7372 HENRY AVE

CIVIL DESIGN PRESENTATION

Date: 2026.09.08

See below for responses to the previous CDR comments:

SITE PLAN

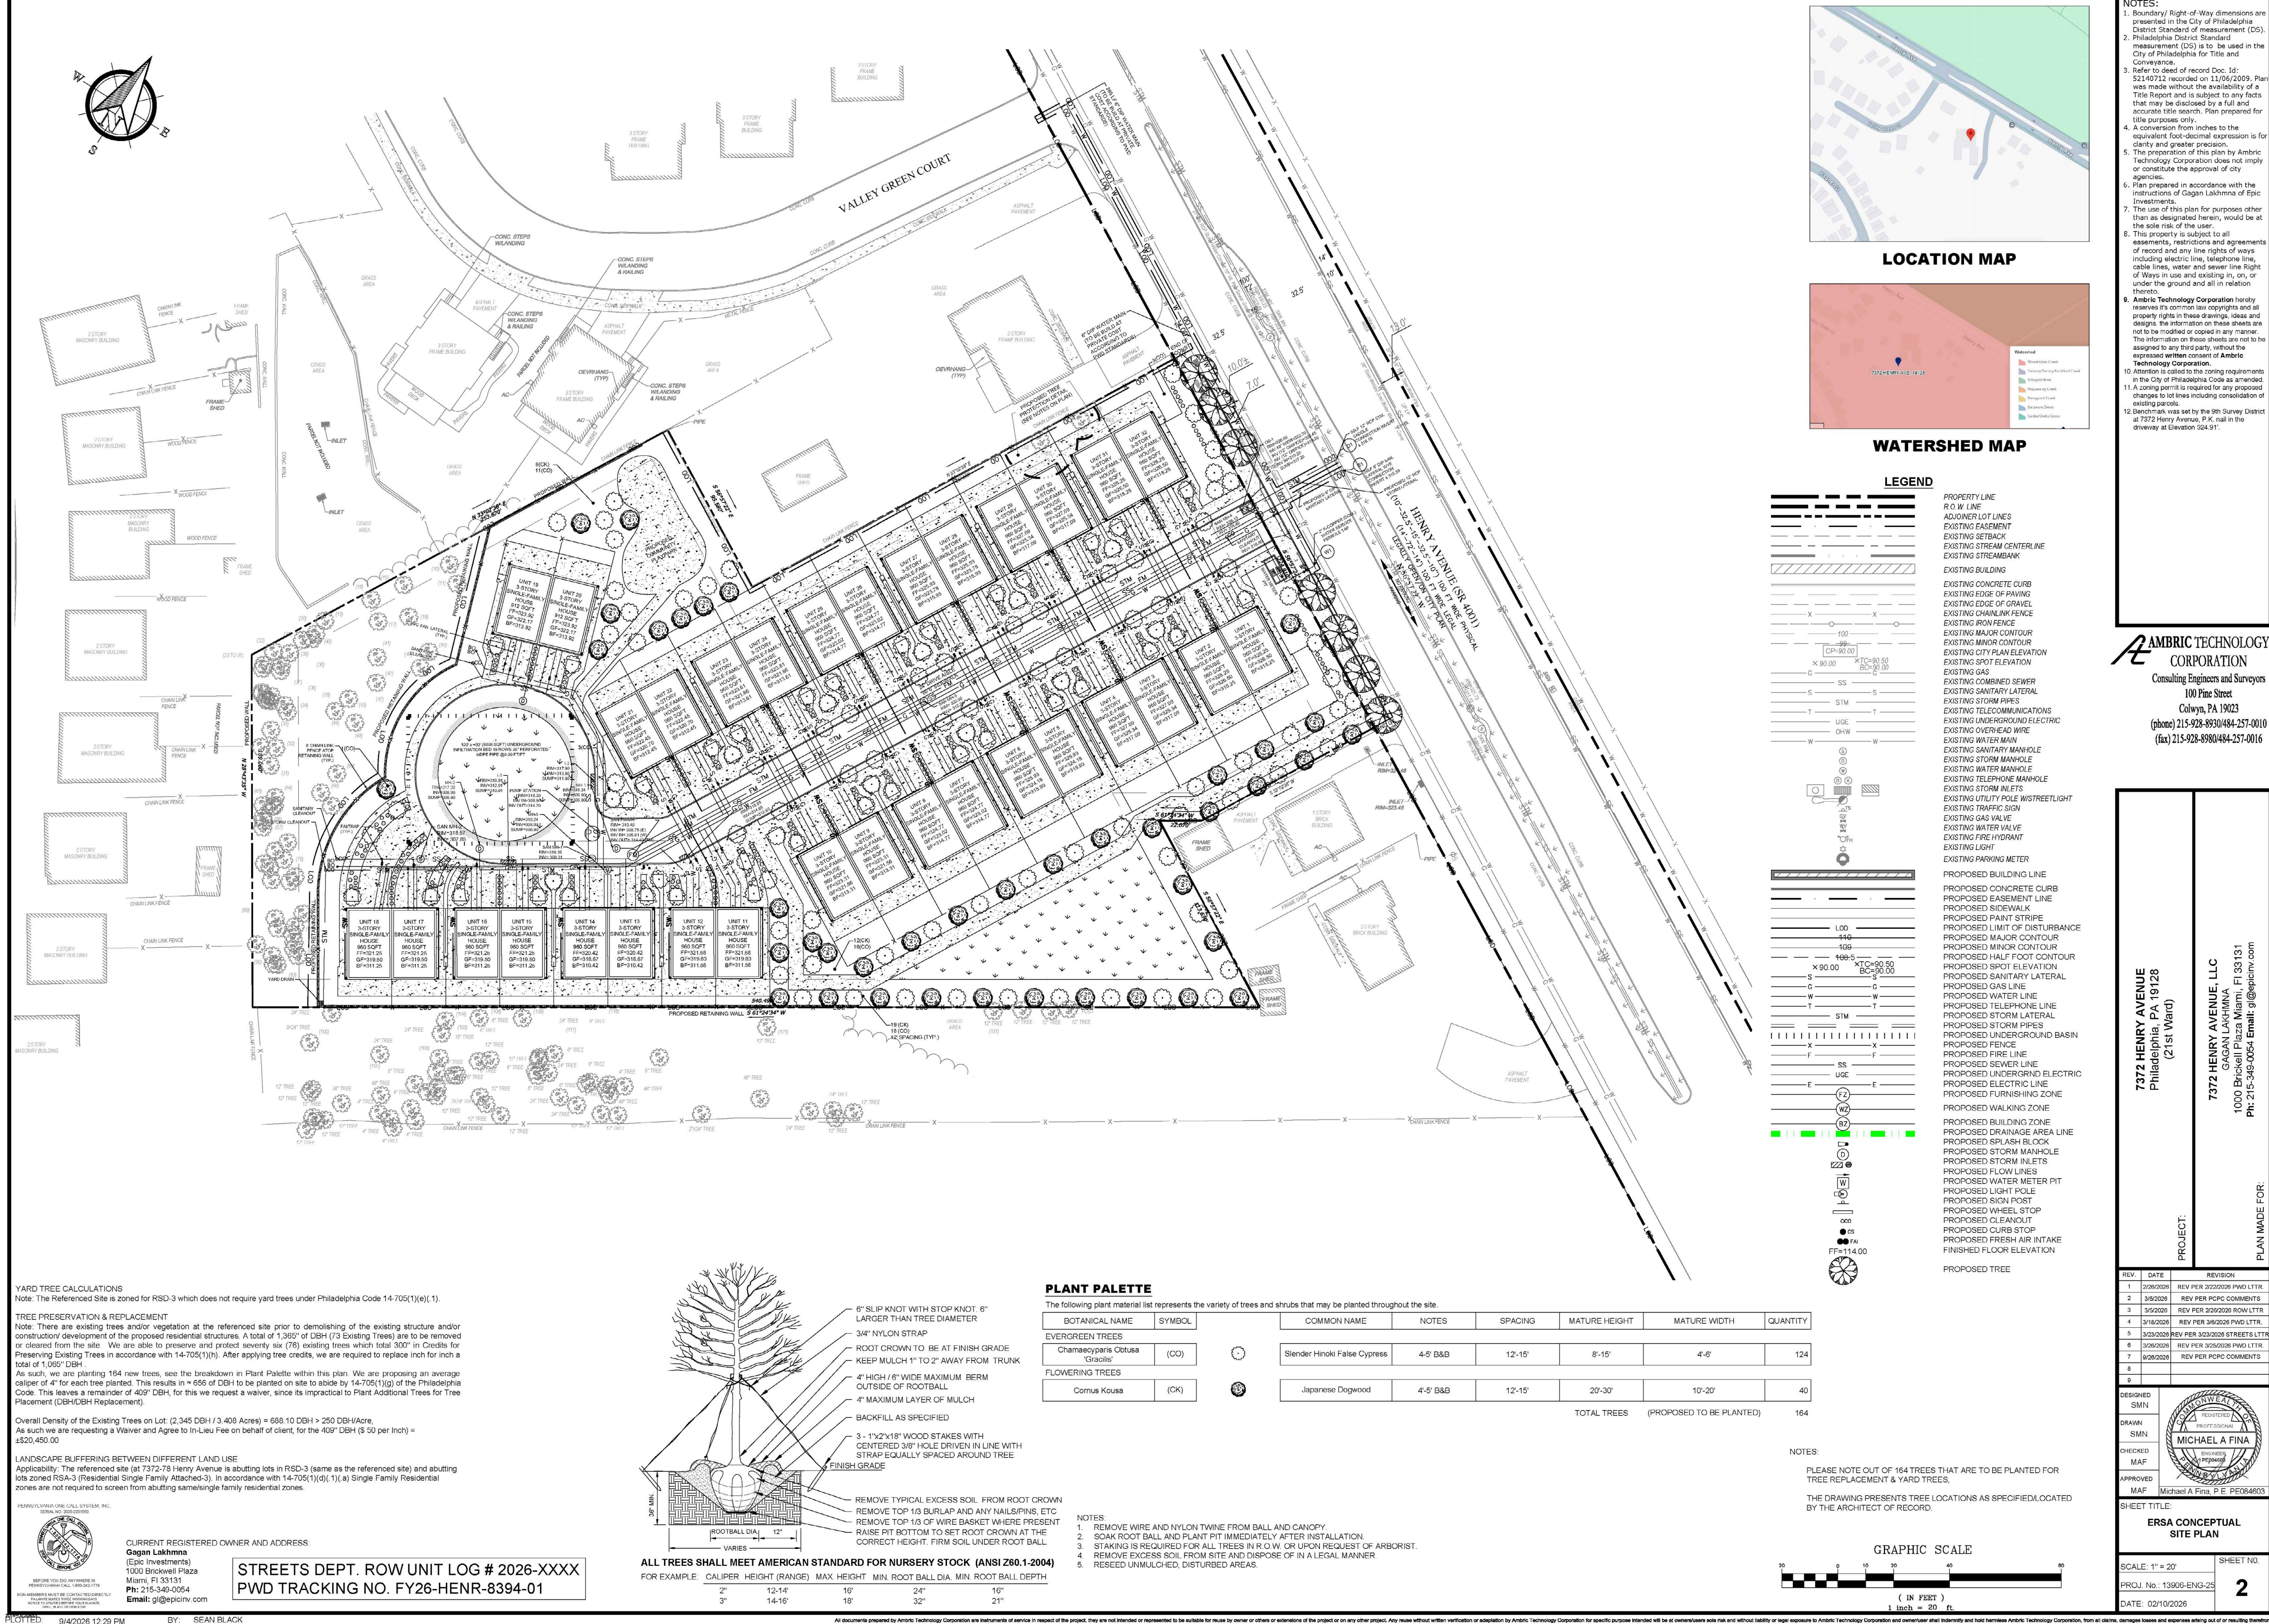
2. Shrink the walking zone on Henry Ave to 8' to accommodate a 4' tree pit. Implement continuous tree pits to ensure healthy tree growth. **These recommendations have been incorporated. Refer to page 08.**

3. Consider expanding the interior sidewalk to 9' to accommodate a 6-foot sidewalk and a 3-foot tree pit. **These recommendations have been incorporated. Refer to page 08.**

4. Consider variety to street frontage depths. **This has not been incorporated, as it would have impacted the rear yards of some homes.**
5. Consider adding a communal space to the center of the cul-de-sac that meets PWD standards. **This recommendation has been incorporated. Refer to page 08.**

6. Prioritize community spaces over parking. Consider adding communal spaces and a playground to the underused green spaces in the corners and the large open area plan south and connect them with pedestrian paths. These need to meet the City's landscape requirements. **These recommendations have been incorporated. Refer to page 08. We now have a play area, a smaller green area in the cul-de-sac, and a neighborhood green space with a loop walking path.**
